APPEAL
Integrated Planning Act 1997

File No. 03-05-015.

BUILDING AND DEVELOPMENT TRIBUNAL - DECISION

Nature of Appeal

Sketch of Ground Level Floor Plan

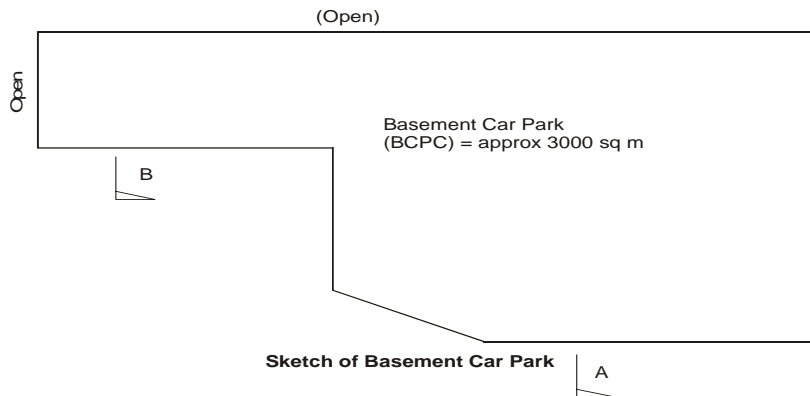
The building certifier and Fire Brigade agree on all aspects of BCA application except for the requirements of clause E2.2(a)(ii) in its requirements to the ground floor level of the building and in particular to the supermarket compartment (SMC).

| BCA Clause | Comment |
|--|--|
| <p>E2.2 General requirements (a) A building must comply with (b), (c), (d) and— (i) Table E2.2a as applicable to Class 2 to 9 buildings such that each separate part complies with the relevant provisions for the classification; and (ii) Table E2.2b as applicable to Class 6 and 9b buildings such that each separate part complies with the relevant provisions for the classification.</p> | <p>Both parties agree that clause E2.2 is directing the reader to Table E2.2b. The information to be determined for this building design is related to the Class 6 section of the building. (ie separate part of the classification)</p> |
| <p>CLASS 6 BUILDINGS—IN FIRE COMPARTMENTS MORE THAN 2000 m²</p> | <p>The speciality shop compartment is not considered as it is less than 2000 m². By continuing the analysis the requirements for supermarket compartment will be determined.</p> |
| <p>(a) Each fire compartment having a floor area of more than 2000 m², other than in a shop described in (b), must be provided with—</p> | <p>The following will apply to supermarket compartment as it is greater than 2000 m².</p> |
| <p>(ii) automatic smoke-and-heat vents complying with Specification E2.2c, if the building is single storey; or</p> | <p>The design of smoke and heat vents is generally through a roof and hence this sub section would generally apply a top floor. However the use of “<i>building</i>” and “<i>single storey</i>” in a sentence with the phrase “<i>building is single storey</i>” indicates “<i>building</i>” refers to the whole not part. i.e. the design relates to a single storey building.</p> |

| <p>(iii) if the floor area of the fire compartment is not more than 3500 m² and the building—</p> | <p>As the supermarket compartment is less than 3500 m² then this section may be applicable. The meaning of “<i>building</i>” has to be determined from reading this and the continuing subsections.</p> |
| <p>(A) is single storey, an automatic smoke detection and alarm system complying with Specification E2.2a; or</p> | <p>The continuing sentence can be read as “<i>if the floor area of the fire compartment is not more than 3500 m² and the building is single storey,</i>” The use of “<i>single storey</i>” suggests a holistic approach and hence “<i>building</i>” refers to the whole and not part. When the building is examined from some elevations it appears to be two storeys. Hence this sub-section would not be applicable as the whole building is not a “<i>single storey</i>”.</p> <p>The alternative way of examining this clause is to make the substitution for “<i>building</i>” ie “<i>part of a building</i>” “<i>if the floor area of the fire compartment is not more than 3500 m² and the part of a building is single storey,</i>” If it was intended to refer to part of the building then the reference to a single storey is incongruous. The appropriate reference would be to a single level.</p> |
| <p>(B) has a rise in storeys of not more than 2, a sprinkler system complying with Specification E1.5.</p> | <p>The continuing sentence can be read as “<i>if the floor area of the fire compartment is not more than 3500 m² and the building has a rise of storeys of not more than 2,</i>”.</p> <p>This is applicable to the case as the building has a rise of storey of 2 and the BCA method of determination of “<i>rise in storey</i>” is based on a holistic approach to the form of the structure.</p> <p>The alternative way of examining this clause is to make the substitution for “<i>building</i>” ie “<i>part of a building.</i>” “<i>if the floor area of the fire compartment is not more than 3500 m² and the part of a building has a rise of storeys of not more than 2,</i>”.</p> <p>Again this is not logical as the method of determination of rise of storey is based on the whole building not part. Hence building refers to the whole and not part. This supports the interpretation of the previous subsection. Hence the requirement for a sprinkler system is a design choice.</p> |

Based on the analysis, it is apparent the designer has a choice of two systems to allow the building to comply with the DTS provisions.

The appropriate choices for the designer to install in the supermarket compartment are either of the following;

- a. an automatic smoke exhaust system complying with Specification E2.2b or
- b. a sprinkler system complying with Specification E1.5

The designers must implement one of the following DTS choices for the Class 6 supermarket compartment.

- a. an automatic smoke exhaust system complying with Specification E2.2b or
- b. a sprinkler system complying with Specification E1.5

Sketch of Basement Car Park

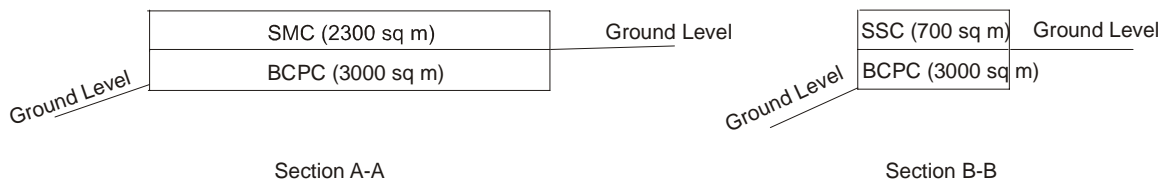
The key components, ie compartments, relating to the application are indicated in the following sketches. It has also been agreed by both parties that the rise in storey is 2. The calculation of rise in storey is as per clause C1.2.

| Description of Compartment | Area |
|--------------------------------------|---------------------|
| Basement Car Park Compartment (BCPC) | 3000 m ² |
